FTC-TR-73-3

**AIR FORCE FLIGHT
EVALUATION (SYSTEMS)
OF THE
A-10A PROTOTYPE AIRCRAFT**

TECHNICAL REPORT No. 73-3

This report presents results of the systems evaluation portion of the A-10A prototype Air Force Flight Evaluation. The A-10A weapon system, as tested by the AFFTC, demonstrated or exhibited the potential for acceptable subsystem performance for conduct of the close air support mission. There were many features that were outstanding, or enhanced the aircraft's capability to perform its design mission. These included bombing and strafing accuracy, armament control, cockpit visibility, auxiliary power unit, and maintainability. There were several deficiencies that could have a mission impact and/or safety implication. The most important items included engine/airframe incompatibility, accessibility of cockpit controls, unacceptable operation of the heading and reference system, pilot discomfort caused by the ejection seat, and unacceptable manual reversion control in pitch. Correction of these and other deficiencies contained in this report should be accomplished on any production version of the aircraft. Evaluation of these corrections is mandatory to insure satisfactory

Figure 1

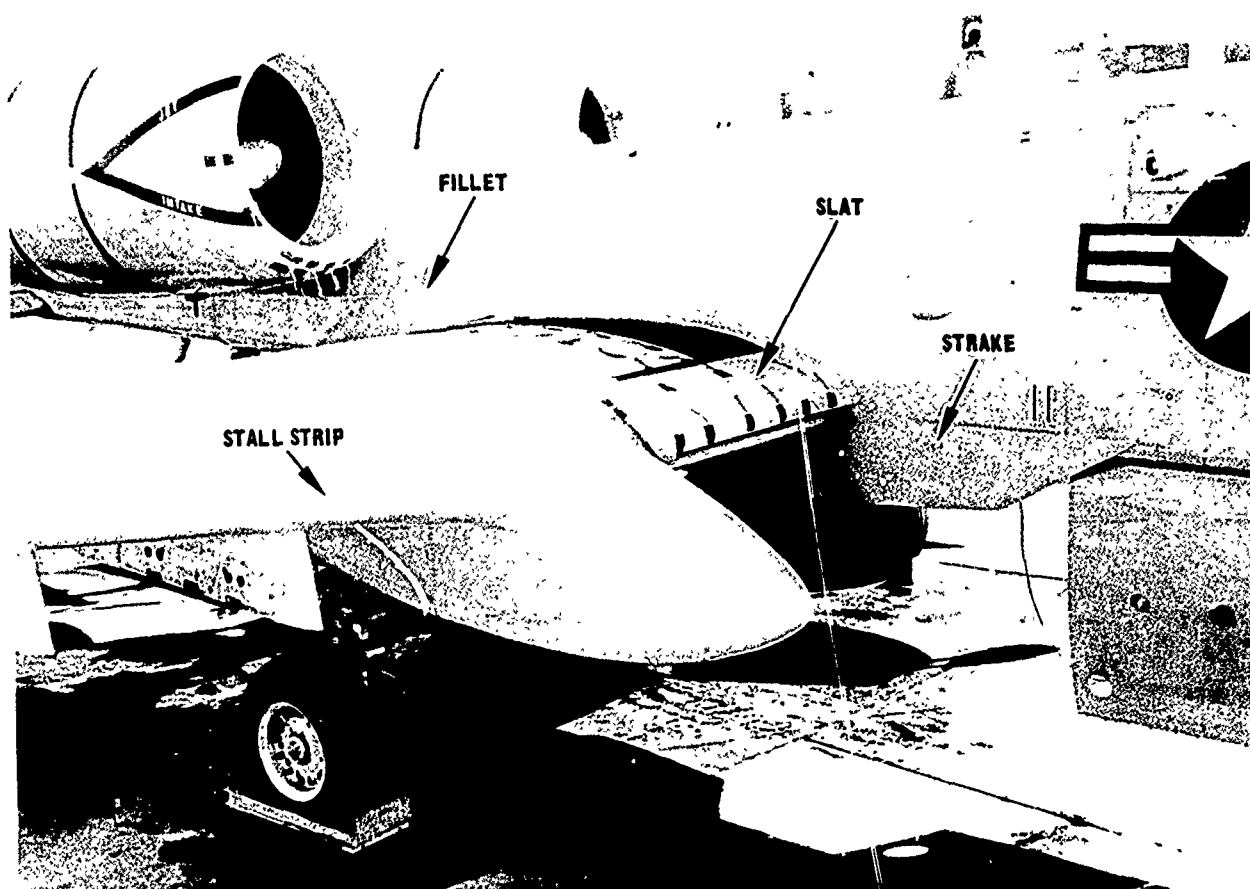
Tests were conducted after completion of Task II to evaluate contractor modification of the A-10A airframe as a solution to the YTF34 engine/A-10A airframe incompatibility problem. This deficiency was documented in the Propulsion-Normal Operations section of the Systems Evaluation Test Results. The modifications consisted of several aerodynamic changes to the A-10A airframe. A fixed, single slotted leading edge slat was installed on the inboard section of each wing between the fuselage and the main landing gear pod. A 24 inch wing leading edge stall strip was located approximately one and a half feet outboard of each gear pod. Also, a filet between the wing and the fuselage at the aft wing root was added. Lastly, a vertical strake was mounted on the fuselage forward of and just below each wing. The complete configuration is shown in Figure 1.

RECOMMENDATION SER NUMBER 10-35-27 CONTINUED:

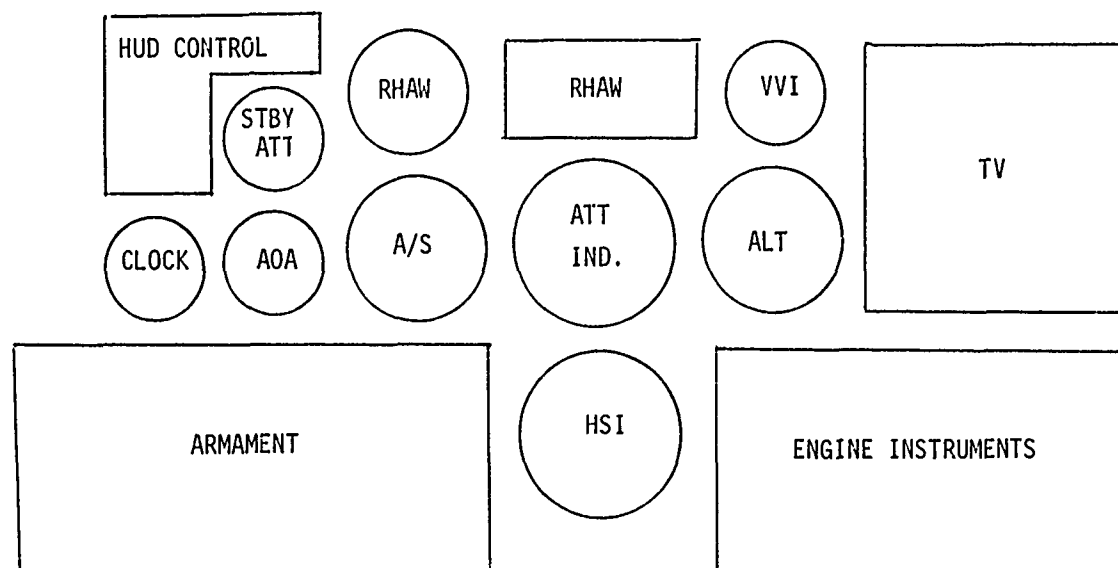
LOCAL ACTION					
None.					
RECOMMENDATION					
Considering the capability of the aircraft to fly missions of long duration, the lack of an autopilot, and the probability of encountering instrument weather conditions in the low altitude environment, priority on instrument panel space should be given to produce the most efficient grouping of primary flight instruments. The VVI					
RECOMMENDATION/DEFICIENCY CLASSIFICATION AND MISSION IMPACT					
☐ FUNCTIONAL ☐ OPS ☐ DESIGN ☐ MATERIEL ☐ QC ☐ MAINT ☐ RELIABILITY ☒ PSTE					
SAFETY HAZARD CODE (MIL-STD-882)		CORRECTION CATEGORY		MISSION IMPACT	
☐ I ☒ II ☐ III ☐ IV		☒ MANDATORY ☐ DESIRABLE		☐ LOSS ☐ VEHICLE ☐ DAMAGE ☐ SUBSYSTEM ☐ INJURY ☐ PERSONNEL (None)	
				☐ PREVENTS ☐ MISSION ☒ DEGRADES ☐ MAINTENANCE ☐ RESTRICTS ☒ SYSTEM PERFORMANCE ☐ DELAYS ☐ FLIGHT/MAINTENANCE CREW EFFECTIVENESS	
AMPLIFICATION/OTHER					
SER CONTACT (Name and grade)		ORGANIZATION (Office Symbol)		DUTY PHONE

should be moved closer to the altimeter and the AOA indicator should be placed in the location presently occupied by the VVI next to the airspeed indicator. Two schemes could be used to provide room for the VVI to be located next to the altimeter:

(1) Remove the APU instruments from the front panel, rearrange the engine instrument panel, and place the VVI in the position occupied by the fan tachometers.

(2) Place the VVI above the altimeter in the position reserved for the RHAW system. Replace the HUD control panel with the RHAW system. Redesign the HUD control panel to use the space presently occupied by the AOA indicator, the fire detect and bleed air leak check button and the fire agent discharge switch. Remove the fire detect and bleed air leak check button from the front panel and relocate it on the lower edge of the caution light panel next to the caution light panel test button. This would improve the functional grouping of light test buttons. Redesign and relocate the fire agent discharge switch to the edge of the glareshield between the fire handles. This would improve functional grouping.

RECOMMENDATION SER NUMBER 10-39-28 CONTINUED:

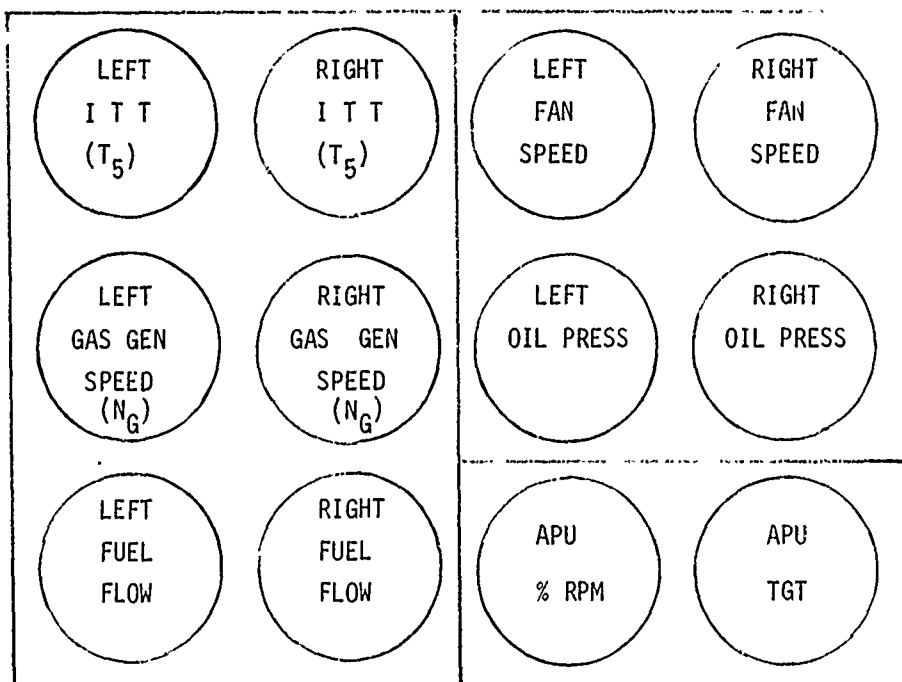
☐ FUNCTIONAL ☐ OPS ☐ DESIGN ☐ MATERIEL ☐ QC ☐ MAINT ☐ RELIABILITY ☒ PSTE				
SAFETY HAZARD CODE (MIL-STD-882)	CORRECTION CATEGORY	POTENTIAL HAZARD	MISSION IMPACT	
☒ I ☐ II ☐ III ☐ IV	☐ MANDATORY ☒ DESIRABLE	☐ LOSS ☐ VEHICLE ☐ DAMAGE ☐ SUBSYSTEM ☐ INJURY ☐ PERSONNEL (None)	☐ PREVENTS ☐ MISSION ☒ DEGRADES ☐ MAINTENANCE ☐ RESTRICTS ☐ SYSTEM PERFORMANCE ☐ DELAYS ☒ FLIGHT/MAINTENANCE CREW EFFECTIVENESS	
AMPLIFICATION/OTHER				
SER CONTACT (Name and grade)		ORGANIZATION (Office Symbol)	DUTY PHONE	
R.D. BRIDGES, JR., Captain		6510TGH	72491	
PROJECT ENGINEER (Typed/printed name and grade)		SIGNATURE	DATE	
FRANK N. LUCERO, GS-13		<i>Frank N. Lucero</i>	15 Nov 72	
PROJECT MANAGER (Typed/printed name and grade)		SIGNATURE	DATE	
GEORGE P. LYNCH, JR., Major, USAF Director, A-X Joint Test Force		<i>George P. Lynch</i>	16 Nov 72

ENGINE INSTRUMENT REARRANGEMENT
